Hydromorphology Supplementary Information

Project name Balliemanoch Pumped Storage Hydro	Client ILI Pump Storage Hydro PLC	Subject CAR Application Request for Further Information	Date 27 February 2026
Prepared by [REDACTED]	Checked by [REDACTED]	Verified by [REDACTED]	Approved by [REDACTED]

Figure 3-1 Location of the watercourses affected by the proposed PSH scheme showing flow direction and photo locations

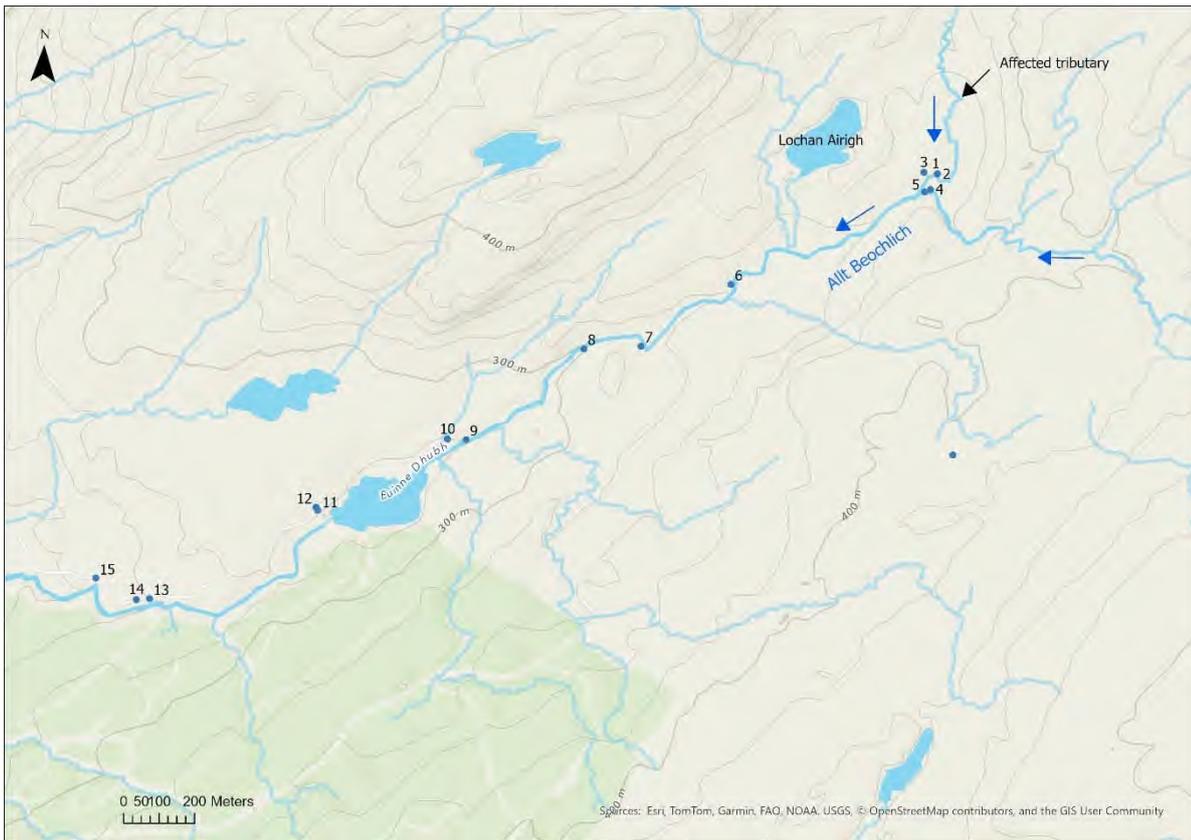
- *Form D (section 4.17) states “sediment load expected to be low based on existing morphology”*
- *Please provide details of how this conclusion was reached.*

The watercourse directly impacted by the Proposed Headpond is a tributary to the Allt Beochlich, shown on **Figure 3-1**. Photographs of this tributary are included in **Figure 3-2** to **Figure 3-4** and the superficial geology map of the area is given in **Figure 3-5**. Channel typology of the affected tributary is predominantly bedrock, with some cobbles visible but a general lack of alluvial features (e.g., gravel bars and riffles). There is also a general lack of superficial deposits as shown on British Geological Survey (BGS) mapping¹, implying that bedrock is at or near the surface throughout the catchment. Bedrock geology is predominantly Tayvallich Volcanic Formation (metalava and metatuff). The lack of superficial deposits combined with the hard, igneous bedrock and the coarse, bedrock-dominated nature of the channel implies that rates of sediment production and transport on the affected tributary are likely to be low.
